SUBJECT: FIRST/Planck 2nd SPIRE technical meeting.

PLACE: ESTEC (Ea112)

Date : 17/11/1998
Ref : PT-MM-06067
Page : 7 of 7

Subject : Technical/Schedule and Management Meeting with SPIRE

The figure 2 shows different connector layouts:

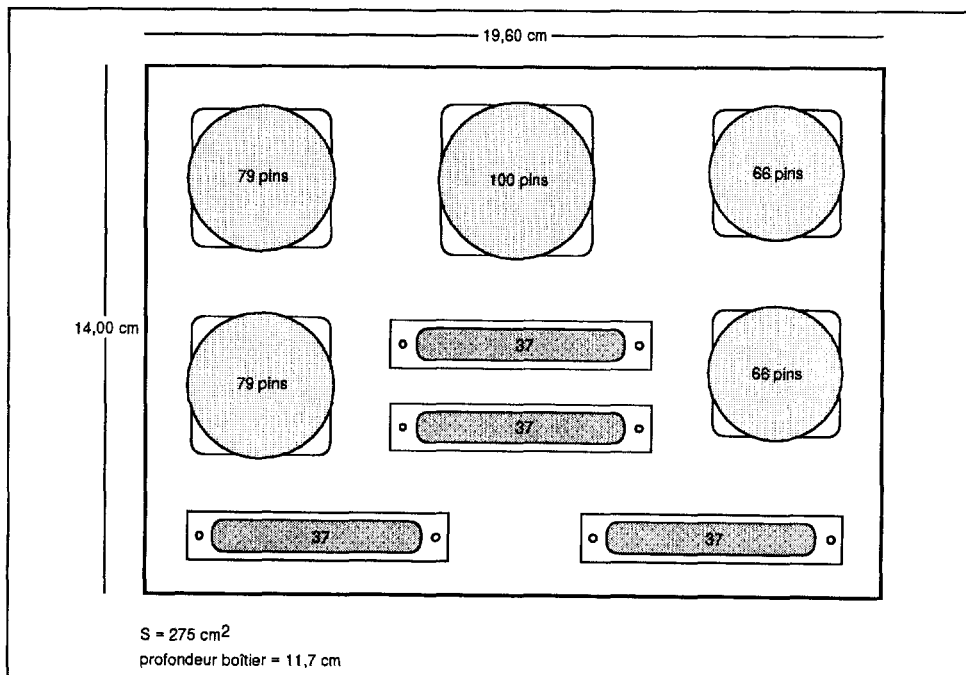
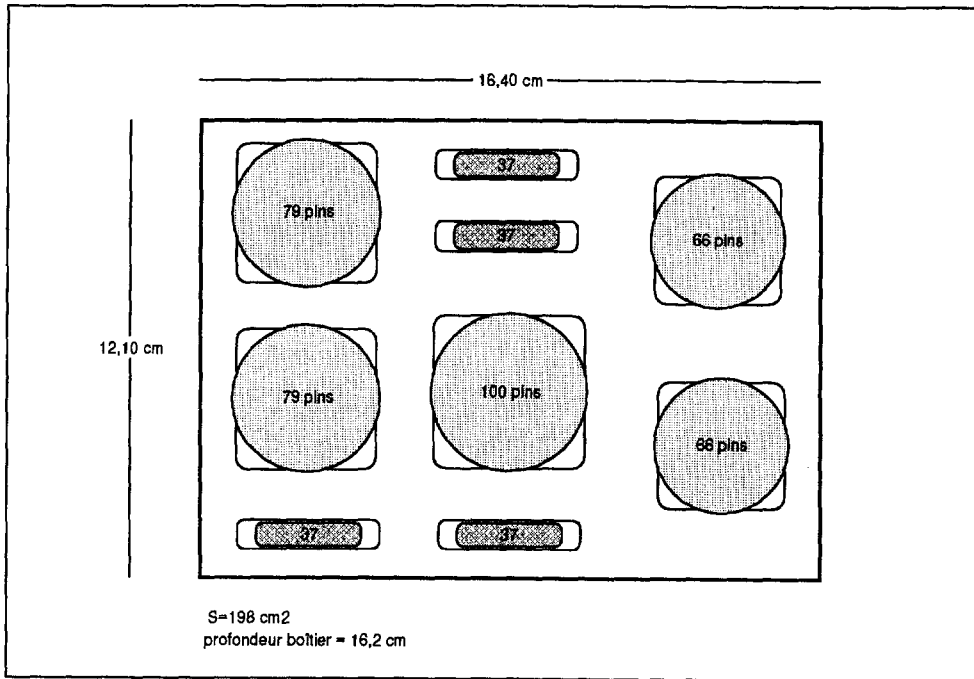
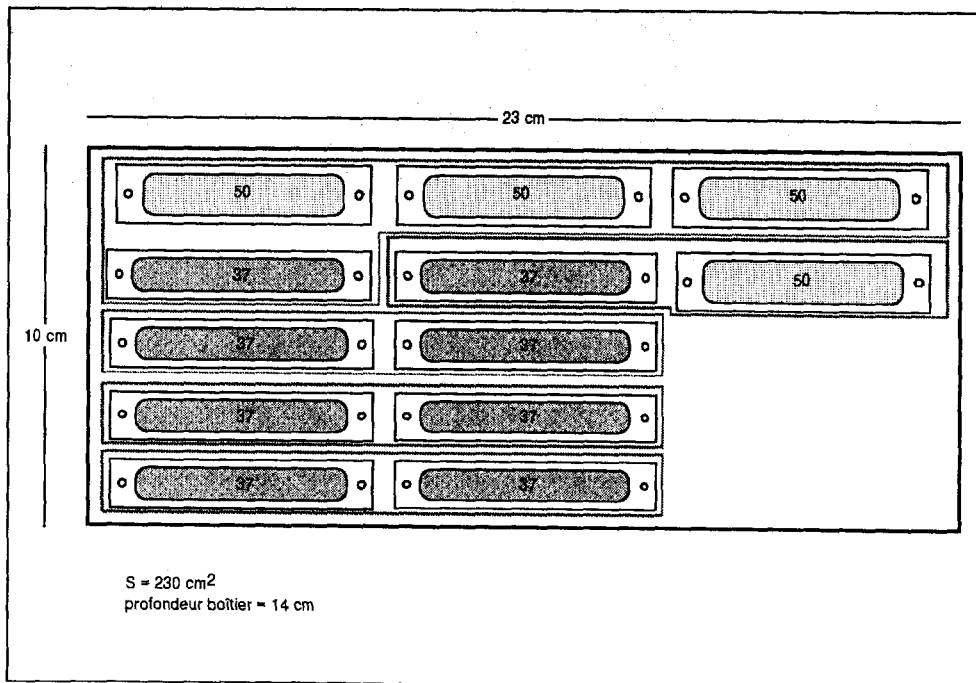
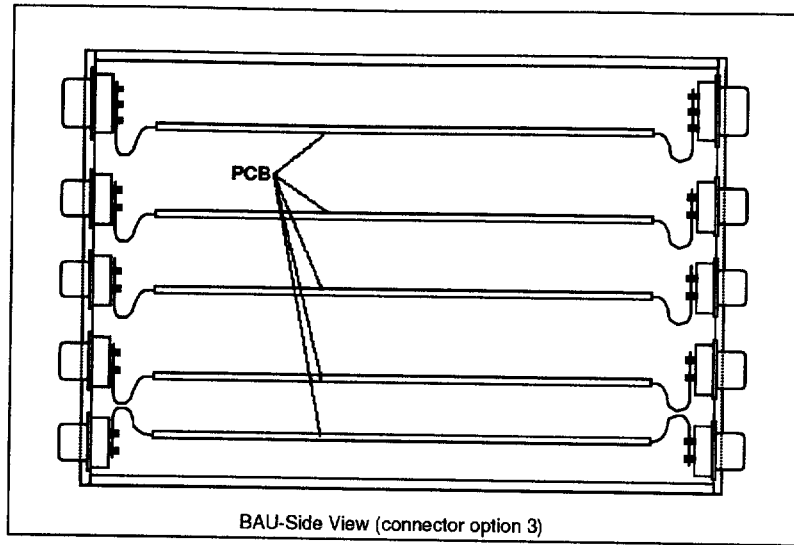
- 1) Should all connections go over the BAU? Eg filter filters*
- 2) BAU power consumption*
